Sony Service Company
 National Technical Services
 A Division of Sony Electronics Inc.
 San Diego, Ca 92127

KDL-40W580B, KDL-40W590B, KDL-40W600B
 KDL-48W580B, KDL-48W590B, KDL-48W600B

No. E58409669

BAX-L / BAX-L HM Main Board Information

Table 1

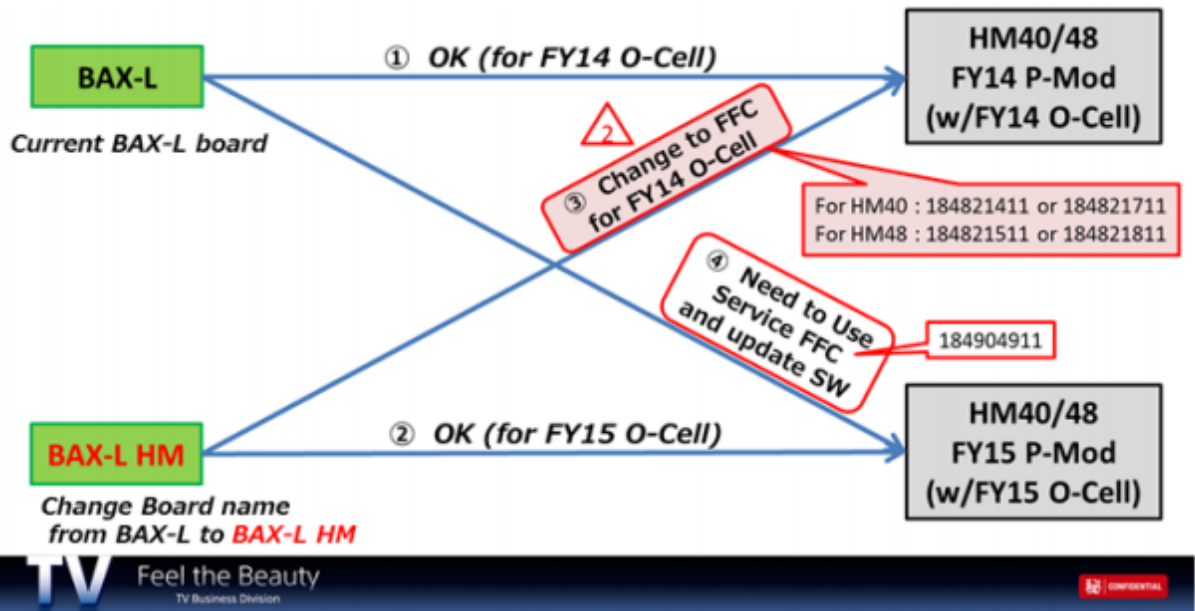
Compatibility issue when changing board type.

New LCD, Main board and Flexible Flat Cable combination.

Case ③ : Need to use FFC for FY14 O-Cell

Case ④ : Need to use Service FFC and update SW (latest) before this change *SW PKG 2.282 or the latest

Replace parts to match accordingly by serial number.
 Use correct Flexible Flat Cable if changing board type.
 Update software to latest version.

For HM40 : 184821411 or 184821711 For HM48 : 184821511 or 184821811
